TECHNICAL SERVICE BULLETIN

TSB #:	TSB-VAR117	ENGINE:	ALL 6.0L PRODUCTS
DATE:	01/17/2017	ISSUED BY:	SERVICE

6.0 LITER VARIATIONS

FIRST STYLE BRANCH TUBE

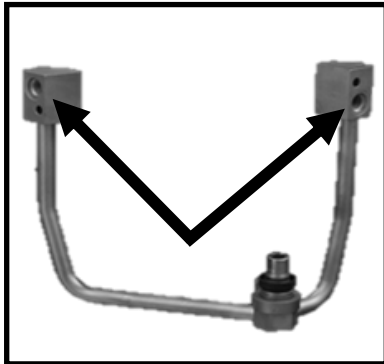
THREADED STAND PIPE CONNECTION WITH QUICK CONNECT OIL PUMP CONNECTION

SECOND STYLE BRANCH

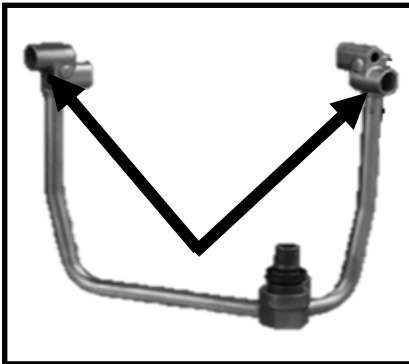
PRESS IN O-RING CONNECTION WITH QUICK CONNECT OIL PUMP

THIRD STYLE BRANCH TUBE

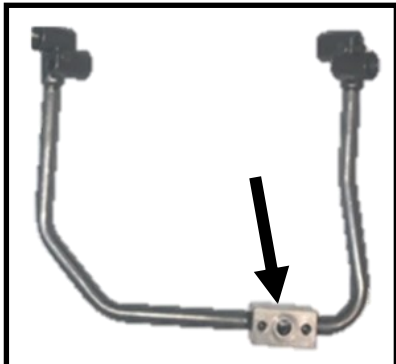
PRESS IN O-RING CONNECTION WITH NEW STYLE FUEL TUBE CONNECTION
